**SUBJECT: ENGINE MOUNT INSPECTION AND REPAIR OR REPLACEMENT**

MODELS AFFECTED: All Mooney M20C, M20D, M20E, M20F and M20G aircraft with 400 or more hours time in service as listed below:

FIGURE 1.
(View Looking Forward)

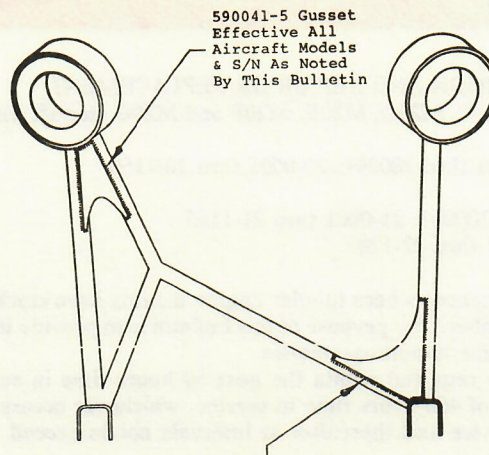
INTRODUCTION: There have been instances where tubular engine mounts have cracked at the upper left and lower right ends of the lower diagonal cross-member. The purpose of this bulletin is to provide instructions for inspection and repair or replacement of these tubular engine mount assemblies.

INSTRUCTIONS: Remove cowl and visually inspect entire engine mount for cracks. Particularly note the juncture of the diagonal cross-member at both the lower right firewall attachment saddle and the upper left attachment to the engine mount ring. (Left and right as viewed facing forward, Ref. Fig. 1) Proceed as follows:

ENGINE MOUNT REPAIR: The engine mount repair consists of the addition, by welding, of two flat gussets at each end of the lower diagonal cross-member. These gussets may be ordered from your local Mooney Service Center (Service Kit #M20-192-1) or fabricated locally per attached actual size drawing (see Fig. 2).

1. Remove engine and engine mount from the aircraft. (Ref. Mooney M20 Series Service and Maintenance Manual - paragraphs 3-7 through 3-10).
2. Refer to Fig. 1 and remove paint from mount in two areas to be welded. Close cracks by welding.
3. Fit gussets into place per Fig. 1 and arc or heliarc weld in accordance with recommendations set forth in AC-43.13-1A Chapter 2, Section 2. NOTE: Mount and gussets are 4130N steel)
4. Clean, re-prime, and re-paint bare areas of mount assembly.
5. Re-install mount, engine and cowling per Service and Maintenance Manual.
